## MB51 - AR5005G Based 802.11b/g Type IIIb Mini PCI

1	Atheros Communications, Inc. 529 Almanor Avenue Sunnyvale, CA 94085							Title MB51				
	Date Wednes	sday, July 14, 2004	Size C	Rev	000	Sheet	1	of	5	245-01268-083

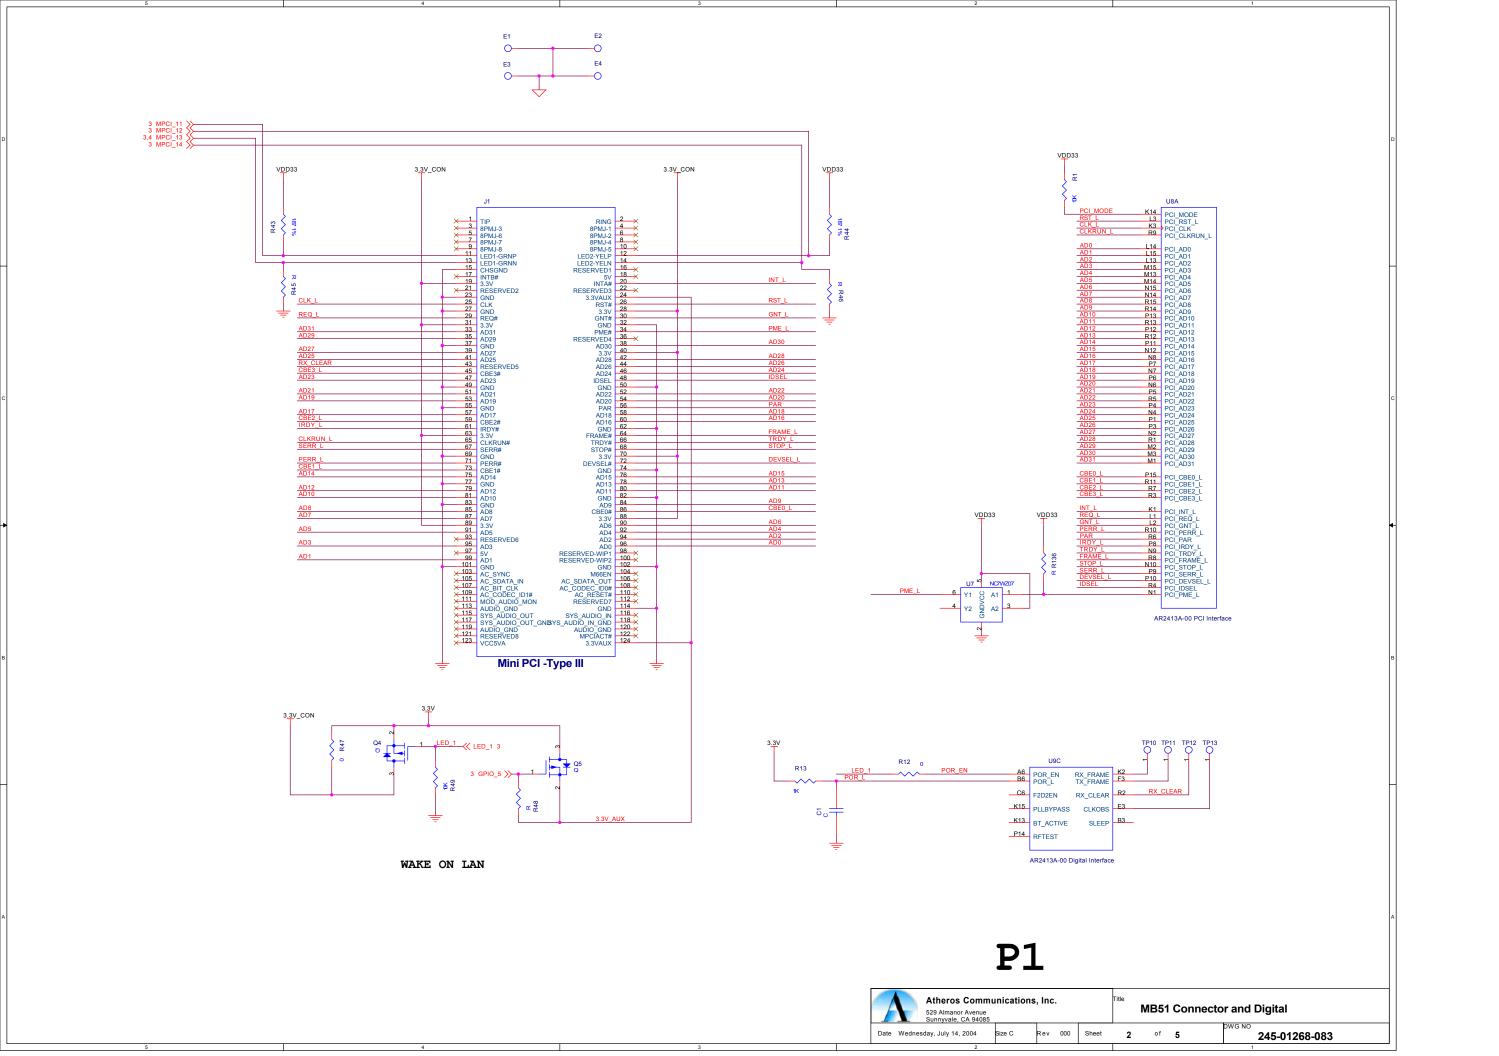
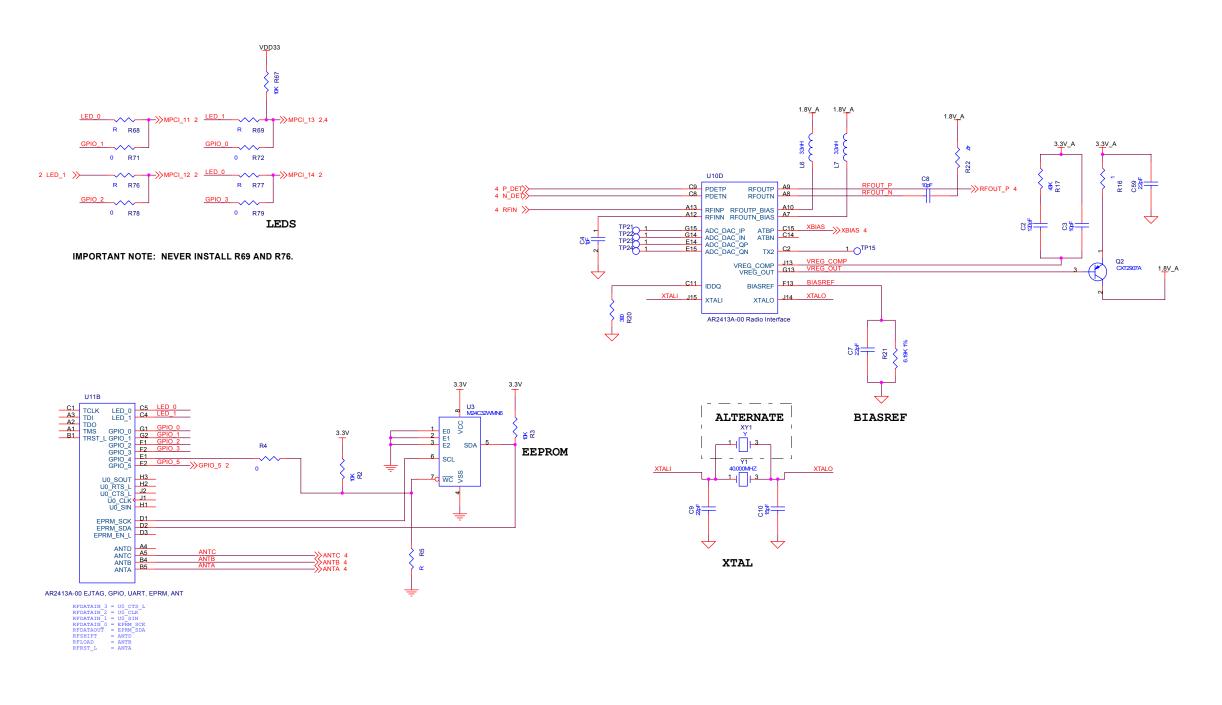
1/8/04   245-01268-010, Rev 000   CL	BATE	REVISION NUMBER	INITIALS	1) Change C22 to R131. Change C24 to R134. Change C29 to R133. Change C42 to L13. Change L10 to C147. Delete C23, C25. And C143, 1uF, 0603 to input of VR3.
Change R53 from 2.2k to 1.1k. Change R52 from 1.5k to 750   3] XLNA input match: Change C45 from 10pf to 15pF Change C47 fom 1pf to 1.5pf   4] XTAL: Change C9 from 24pf to 22pf. Change C10 from 10pf to 15pF   5] XTAL: Change C9 from 24pf to 22pf. Change C14 from 10pf to 15pF   6] XTAL: Change C9 from 24pf to 22pf. Change C14 from 3.3pf DNL Change C3 from 10pf to 15pC DNL Change R31 from 10 to 0. Change R32 from 22 to 0. Change R129 from 0 to 10p. Change R310 from 10 to 150   3] XPA Supply: Change R130 from 10 to 150   3] XPA Supply: Change C77 from 10pf to 15pf. Change C16 from 4.7uf to DNL Change VR3 from 40 from 4.7uf to DNL Change VR3 from 40 from 4.7uf to DNL Change VR3 from 40 from 4.7uf to DNL Change C47 from 10pf to 15pf. Change C47 from 4.7uf to DNL Change C47 from 10pf to 15pf. Change C47 from 4.7uf to DNL Change C47 from 50 from 50 from 50 from 4.7uf to DNL Change C47 from 4.7uf to DNL Change C47 from 50 from 50 from 50 from 50 from 50 from 4.7uf to DNL Change C47 from 4.7uf to 15pf to 12pf 4 (2pf 4)	1/8/04	245-01268-010, Rev 000	CL	Add RF Kill Circuit R135,0402, Q7, 2N3906.

1.5pF 4) XTAL: Change C9 from 24pF to 22pF. Change C10 from 10pF to 15pF 3/17/04 245-01268-030, Rev 000 CL 1) RF_IN Match: Change L13 from 1.6nH to C149 2.2pF. Change C147 from 3.3pF DNI. Change C78 from 10pF to R137 0.5hm 2) XPA Blas: Change R111 from 10 to 10. Change R31 from 22 to 0. Change R129 from 0.5 to 10p. Change R120 from 0.5 to 10p. Change C140 from 10p. to 5.8pF 4) 1.5x Regulator: Change C3 from DNI to MMBT2907A. Change C140 from 4.7x to 10p. Change VR3 from AME886MBFTto DNI 9) RPGUT_BIAS: Change L8 supply from 3.3v_A to 1.8v_A. Change L7 supply from 3.3v_A to 1.8v_A. 6) PME_L: Add R13s 10k (0402) pullup 7) XLNA Blass: Change C3 from 0.01uF to DNI 8) XPA: Change U8 from XS552E to 6F1214  245-01268-031 CL 1) XLNA: Change C41 from 10pF 14 to 10pF 5% 2) RF_IN Match: Change C41 from 10pF 10 7.2pF 3) Bypsassing: Change C59 from 10pF to 7.2pF 4) External Detector: Change R61 and R84 from 1.1k to 5.1k 5) XPA Blass: Change R127 from 10 to 100 (again) 4/1/104 245-01268-032 CL 1) Mode Pins: Change R17, R3 from 10k 11 kto 10k 5% 2) RF_KIII: Change R67 from DNI to 10k 3) PME: Change R135 from 10k to DNI (10k) 4/27/04 245-01268-050 JW Changed R7 fro 0402. Disconnect J1, p15. Delete R2 and siege net. Sway U P8.P8. Remove R50. Remove Q6. Change R48 to R between 3.3v_AUX and GPIO_3. Changed R73 from 10k to DNI (10k) 4/27/04 245-01268-050 JW Changed R71 to 0402. Disconnect J1, p15. Change C8 from 10pF. Changed C77, C25, C38, C43, C44, C74 to 3.0pF. Changed C77, C25, C38, C43, C44, C74 to 3.0pF. Changed C77, C25, C38, C43, C44, C74 to 3.0pF. Changed C77, C25, C38, C43, C44, C74 to 3.0pF. Changed C77, C25, C38, C43, C44, C74 to 3.0pF. Changed C77, C25, C38, C43, C44, C74 to 3.0pF. Changed C77, C25, C38, C43, C44, C74 to 3.0pF. Changed C77, C25, C38, C43, C44, C74 to 3.0pF. Changed C77, C25, C38, C43, C44, C74 to 3.0pF. Changed C78 to 11, S74, Change C78 to T0pN. to 11, S74, Change C78 to 10pN. to 11, S74				Change R53 from 2.2k to 1.1k. Change R52 from 1.1k to 750

2) XPA Bias: Change R111 from 10 to 0. Change R131 from 22 to 0. Change R129 from 0 to 100. Change R132 from 0 to 105 (3) XPA Supply: Change C77 from 10pF to 5.6pF. Change C76 from 10pF to 5.6pF.	3/17/04	245-01268-030, Rev 000	CL	1) RF_IN Match: Change L13 from 1.6nH to C149 2.2pF. Change C147 from 3.3pF to

5) RFOUT_BIAS: Change L6 supply from 3.3" A to 1.8" A. Change L7 supply from 3.3" A to 1.8" A. 6) PME_L: Add R136 10K (0402) pullup 7) XLNA Bias: Change G3 from 0.01tl fo DNI 8) XPA: Change U6 from LX5512B to GP1214  3/36/04 245-01268-031				4) 1.8V Regulator: Change Q2 from DNI to MMBT2907A. Change C140 from 4.7uF

3/38/04				7) XLNA Bias: Change C39 from 0.01uF to DNI
2   RF, IN Match: Change C4 from 10pF to 1pF   3) Bypassing: Change C59 from 10pF to 2.2pF   4) External Detector: Change R81 and R84 from 1.1K to 5.1K   5) XPA Blas: Change R12 from 10 to 100 (again)   4/1/104   245-01268-032   CL   1) Mode Pins: Change R1, 37 from 10k 1% to 10k 5%   2) RF Kill: Change R67 from DNI to 10k (10k)   245-01268-040   JW   Change R67 from DNI to 10k to DNI (10k)   Change R136 from 100k to DNI (10k)   Change R67 from DNI to 10k (10k)   Change R67 from DNI to 18v (10k)   Change R67 from DNI to 10k (10k)   C				8) XPA: Change U6 from LX5512B to GP1214
3] Bypassing: Change C59 from 10pF to 2.2pF	3/30/04	245-01268-031	CL	1) XLNA: Change C41 from 10pF 1% to 10pF 5%

4) External Detector: Change R81 and R84 from 1.1K to 5.1K 5) XPA Bias: Change R129 from 10 to 100 (again) 4/1/04 245-01268-032 CL 1) Mode Pins: Change R1, from 10K to 10K 5% 2) RF Kill: Change R67 from DNI to 10K 3) PME: Change R136 from 100K to DNI (10K) 4/6/04 245-01268-040 JW Change R6, C14 to 0.402. Disconnect J1, p16. Delete R2 and sleep net. Swap U P8, P9. Remove R50. Remove GC change R48 to R between 3.3V_AUX and GPIO_3. Change R49 to R between LED_1 and GND. 4/27/04 245-01268-050 JW Changed R47 to 0.805 package. Changed R131 to 22 ohms. Changed R133,R134 to 220 ohms. Changed R27 (25.638,643,644,674 to 3.0pF. 4/27/04 245-01268-051 CL Change R133, R134 from 220 5% to 221 1%. Changed C27, C28,C38,C43,C44,C74 to 3.3pF. 5/6/04 245-01268-052 CL POR: Change R12,R13 from DNI to 10k. Change C1 from DNI to 0.1uF 5/28/04 245-01268-060 JW Changed R12 to 0 ohm. Changed C1 to DNI. R12 is now connected to LED_1 instead of 3.3V. 6/4/04 245-01268-070 JW Move C140 to 1.8V_A. Change R48 and R49 to DNI. Remove VR3,C57. Move C148 from 3.3V to 1.8V. Change C1 to U1pE2. Added R4, 0 OHM, to U1 pE1 and U3 p7. Added pullup R2, 10 OHM to U3 p7. Added R5 DNI between GND and U3 p7. Change R16 to 0.603. 6/9/04 245-01268-080 VN Fixed pin out of Q2. Changed R13 to 1K. Disconnected U1pD3 6/9/04 245-01268-081 CL Excel BOM hand-edited. EPICOM PA added as Alternate Vendor. PCB part numbrup-rev'd as well as header and footer information.

4/27/04       245-01268-050       JW       Changed R47 to 0805 package. Changed R131 to 22 ohms. Changed R133,R134 to 220 ohms. Changed R22 pin 2 from GND to 1.8V_A. Changed C8 to 10pF.         4/27/04       245-01268-051       CL       Change R133, R134 from 220 5% to 221 1%. Changed C27, C28,C38,C43,C44,C74 to 3.3pF.         5/6/04       245-01268-052       CL       POR: Change R12,R13 from DNI to 10k. Change C1 from DNI to 0.1uF         5/28/04       245-01268-060       JW       Changed R12 to 0 ohm. Changed C1 to DNI. R12 is now connected to LED_1 instead of 3.3V.         6/4/04       245-01268-060       JW       Move C140 to 1.8V_A. Change R48 and R49 to DNI. Remove VR3,C57. Move C148 from 3.3V to 1.8V. Change Q2 to S0T89 CXT2907A. Changed Q5p1 to GPIO_5 and connected to U1pE2. Added R4, 0 OHM, to U1 pE1 and U3 p7. Added pullup R2, 10 OHM, to U1 pE1 and U3 p7. Added pullup R2, 10 OHM, to U1 pE1 and U1 pE1 and U1 pE1. Changed R13 to 1K. Disconnected U1pD3         6/9/04       245-01268-080       VN       Fixed pin out of Q2.         6/11/04       245-01268-081       CL       Excel BOM hand-edited. EPICOM PA added as Alternate Vendor. PCB part number up-rev'd as well as header and footer information.         7/6/04       245-01268-082       CL       Changed R130 from 150 to 200.         7/12/04       245-01268-083       CL       Add OEpic as alternate XPA following regulatory certification and ATMEL as	4/6/04	245-01200-040	3 44	P8,P9. Remove R50. Remove Q6. Change R48 to R between 3.3V_AUX and

220 ohms. Changed R22 pin 2 from GND to 1.8V_A. Changed C8 to 10pF. Changed C27, C28,C38,C43,C44,C74 to 3.0pF.  4/27/04 245-01268-051 CL Change R133, R134 from 220 5% to 221 1%. Changed C27, C28,C38,C43,C44,C74 to 3.3pF.  5/6/04 245-01268-052 CL POR: Change R12,R13 from DNI to 10k. Change C1 from DNI to 0.1uF  5/28/04 245-01268-060 JW Changed R12 to 0 ohm. Changed C1 to DNI. R12 is now connected to LED_1 instead of 3.3v.  6/4/04 245-01268-070 JW Move C140 to 1.8V_A. Change R48 and R49 to DNI. Remove VR3,C57. Move C148 from 3.3v to 1.8v. Change Q2 to SOT89 CXT2907A. Changed Q5p1 to GPIO_5 and connected to U1pE2. Added R4, 0 OHM, to U1 pE1 and U3 p7. Added pullup R2, 1t OHM to U3 p7. Added R5 DNI between GND and U3 p7. Change R16 to 0603. Changed R13 to 1K. Disconnected U1pD3  6/9/04 245-01268-080 VN Fixed pin out of Q2.  6/11/04 245-01268-081 CL Excel BOM hand-edited. EPICOM PA added as Alternate Vendor. PCB part numbrup-rev'd as well as header and footer information.  7/6/04 245-01268-082 CL Changed R130 from 150 to 200.				GPIO_3. Change R49 to R between LED_1 and GND.

6/4/04 245-01268-070 JW Move C140 to 1.8V_A. Change R48 and R49 to DNI. Remove VR3,C57. Move C148 from 3.3V to 1.8V. Change Q2 to SOT89 CXT2907A. Changed Q5p1 to GPIO_5 and connected to U1pE2. Added R4, 0 OHM, to U1 pE1 and U3 p7. Added pullup R2, 10 OHM to U3 p7. Added R5 DNI between GND and U3 p7. Change R16 to 0603. Changed R13 to 1K. Disconnected U1pD3 6/9/04 245-01268-080 VN Fixed pin out of Q2. 6/11/04 245-01268-081 CL Excel BOM hand-edited. EPICOM PA added as Alternate Vendor. PCB part number up-rev'd as well as header and footer information. 7/6/04 245-01268-082 CL Changed R130 from 150 to 200. 7/12/04 245-01268-083 CL Add OEpic as alternate XPA following regulatory certification and ATMEL as	5/28/04	245-01268-060	JW	
from 3.3V to 1.8V. Change Q2 to SOT89 CXT2907A. Changed Q5p1 to GPIO_5 and connected to U1pE2. Added R4, 0 OHM, to U1 pE1 and U3 p7. Added pullup R2, 10 OHM to U3 p7. Added R5 DNI between GND and U3 p7. Change R16 to 0603.  Changed R13 to 1K. Disconnected U1pD3  6/9/04  245-01268-080  VN  Fixed pin out of Q2.  Excel BOM hand-edited. EPICOM PA added as Alternate Vendor. PCB part number up-rev'd as well as header and footer information.  7/6/04  245-01268-082  CL  Changed R130 from 150 to 200.  7/12/04  245-01268-083  CL  Add OEpic as alternate XPA following regulatory certification and ATMEL as	0/4/04

OHM to U3 p7. Added R5 DNI between GND and U3 p7. Change R16 to 0603. Changed R13 to 1K. Disconnected U1pD3  6/9/04  245-01268-080  VN Fixed pin out of Q2.  6/11/04  245-01268-081  CL Excel BOM hand-edited. EPICOM PA added as Alternate Vendor. PCB part number up-rev'd as well as header and footer information.  7/6/04  245-01268-082  CL Changed R130 from 150 to 200.  7/12/04  245-01268-083  CL Add OEpic as alternate XPA following regulatory certification and ATMEL as	6/4/04	245-01266-070	3 44	from 3.3V to 1.8V. Change Q2 to SOT89 CXT2907A. Changed Q5p1 to GPIO_5 and
Changed R13 to 1K. Disconnected U1pD3  6/9/04 245-01268-080 VN Fixed pin out of Q2.  6/11/04 245-01268-081 CL Excel BOM hand-edited. EPICOM PA added as Alternate Vendor. PCB part number up-rev'd as well as header and footer information.  7/6/04 245-01268-082 CL Changed R130 from 150 to 200.  7/12/04 245-01268-083 CL Add OEpic as alternate XPA following regulatory certification and ATMEL as				connected to U1pE2. Added R4, 0 OHM, to U1 pE1 and U3 p7. Added pullup R2, 10K

6/11/04 245-01268-081 CL Excel BOM hand-edited. EPICOM PA added as Alternate Vendor. PCB part number up-rev'd as well as header and footer information.  7/6/04 245-01268-082 CL Changed R130 from 150 to 200.  7/12/04 245-01268-083 CL Add OEpic as alternate XPA following regulatory certification and ATMEL as				
up-rev'd as well as header and footer information.  7/6/04 245-01268-082 CL Changed R130 from 150 to 200.  7/12/04 245-01268-083 CL Add OEpic as alternate XPA following regulatory certification and ATMEL as	6/9/04	245-01268-080	VN	Fixed pin out of Q2.
up-rev'd as well as header and footer information.  7/6/04 245-01268-082 CL Changed R130 from 150 to 200.  7/12/04 245-01268-083 CL Add OEpic as alternate XPA following regulatory certification and ATMEL as				
7/12/04 245-01268-083 CL Add OEpic as alternate XPA following regulatory certification and ATMEL as	6/11/04	245-01268-081	CL	
7/12/04 245-01268-083 CL Add OEpic as alternate XPA following regulatory certification and ATMEL as	7/0/04	245 04200 002	01	Channel B420 from 450 to 200
